G. NARRATIVE/REMARKS/COMMENTS

H. RECOMMENDATIONS**1. Recommended Amounts**

System Design 73-7368

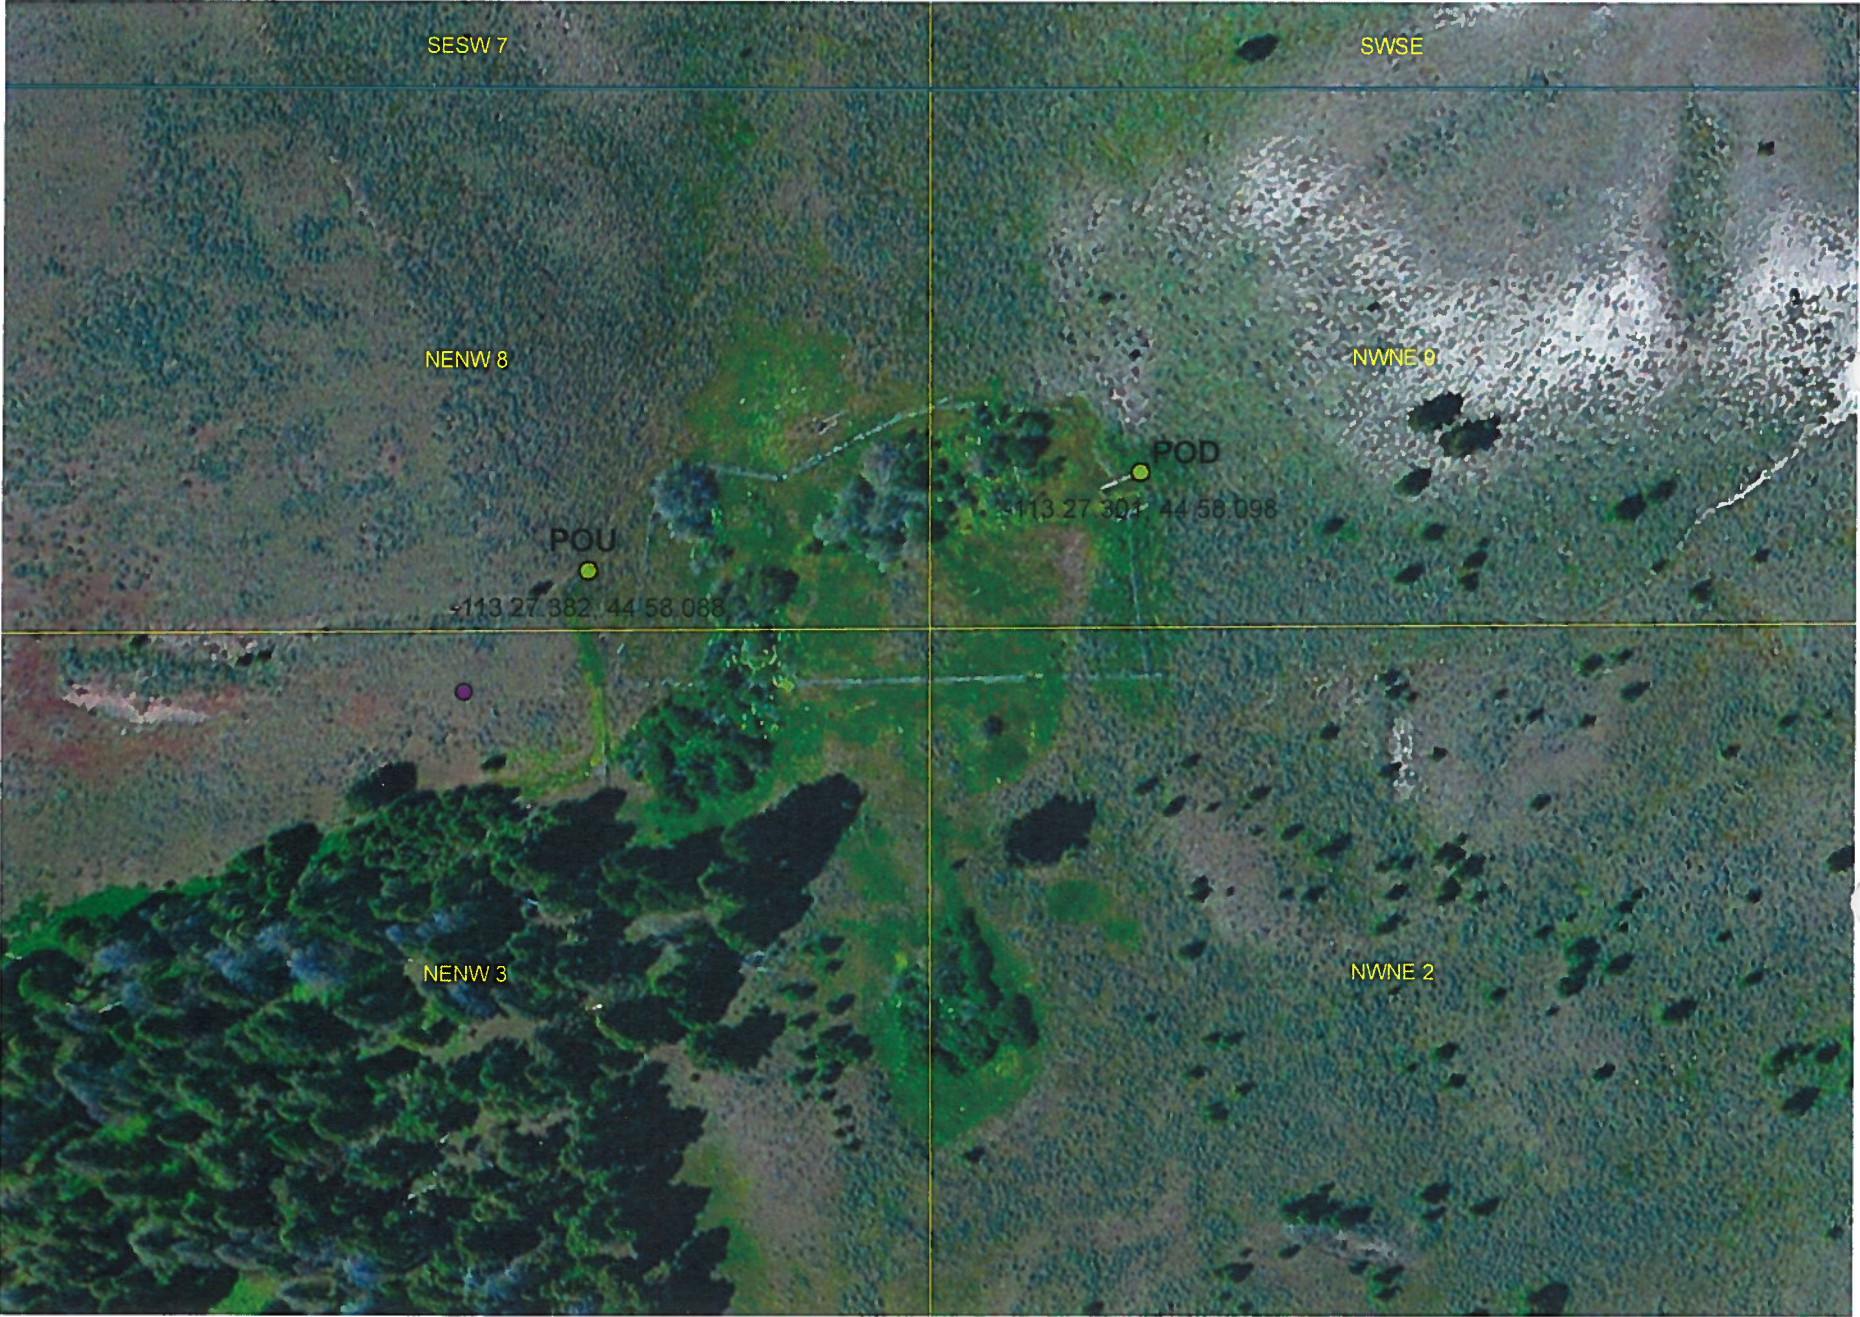
System consists of a wood spring head-box connected to a 1 1/4" poly pipe outflow. Buried pipe runs east to west approximately 425 ft and daylight into 425 gallon trough.

Rob, after being to the development site with you, I agree the POD and POU are correct as shown on the map...
